MEMORANDUM

REVIEW TYPE: Preliminary Plan of Subdivision, Resubdivision of Existing Lot 4
and Parcel A, Block B Taylor Subdivision

PROJECT NAME: Taylor Subdivision

CASE #: 120060550

Figure #2 Taylor Neighborhood Delineation Map

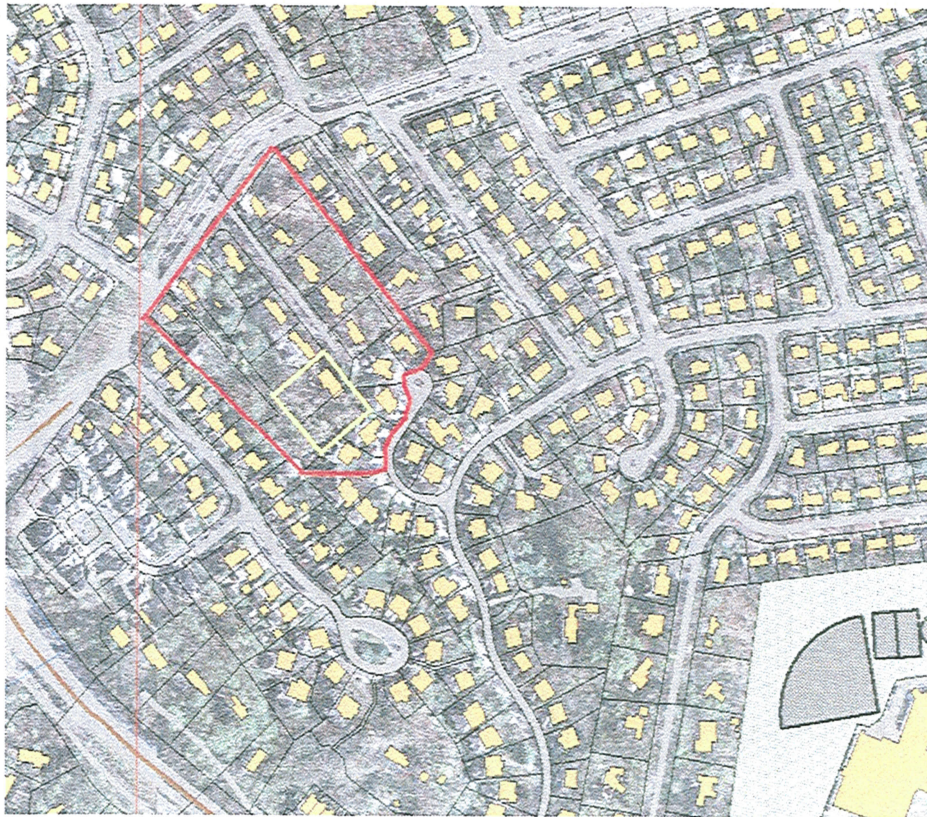
In performing the analysis, Staff applied the resubdivision criteria to the delineated neighborhood. Based on the analysis, the proposed resubdivision will be of the same character as the existing lots in the neighborhood. As set forth below, the attached tabular summary (Attachment D) and graphical documentation support this conclusion:

Frontage: In a neighborhood of 14 lots, lot frontages range from 25.48 feet to 137.36 feet. The proposed lots have frontages of 61 feet and 123 feet. **Therefore, the proposed lot will be consistent in character with other lots in the neighborhood.**

Area: In a neighborhood of 14 lots, lot buildable areas range from 3,479 square feet to 16,734 square feet. The proposed lots have areas of 5,694 and 10,369 square feet. **The proposed resubdivision will be consistent in character with the existing lots in the neighborhood with respect to buildable area.**

Lot Size: The lot sizes in the delineated neighborhood range from 10,042 square feet to 30,119 square feet. The proposed lots will have lot sizes of 14,428 square feet and 19,516 square feet. **Therefore, the lot size of the proposed lots will be of the same character as the existing lots in the neighborhood.**

Lot Width: The lot widths in the existing neighborhood range from 47.54 feet to 116.70 feet. The proposed lots have widths of 112 and 142 feet. Lot 6 will have the greatest width, and is at the highest end of the range of lot widths in the neighborhood. The width of the lot is measured at the front of the dwelling. The proposed dwelling on Lot 6 is depicted on the plan to be placed horizontally on the lot due to the irregular lot shape. This placement of the dwelling creates a greater width, but is not out of character with the other lots in the existing neighborhood. **As such, Lot 5 and Lot 6 will be in character with the existing lots in the neighborhood.**

Shape: The existing lots in the neighborhood consist of one (1) pipestem shaped lot, seven (7) irregularly shaped lots and six (6) rectangular shaped lots. **The plan proposes two irregular lots, which will be consistent in character with the existing lots in the neighborhood.**

Alignment: There is one (1) angular lot in the neighborhood, two (2) corner lots, three (3) radial lots and eight (8) perpendicular lots in the neighborhood. **The plan proposes two (2) radial lots, which will be in character with the other lots in the neighborhood.**
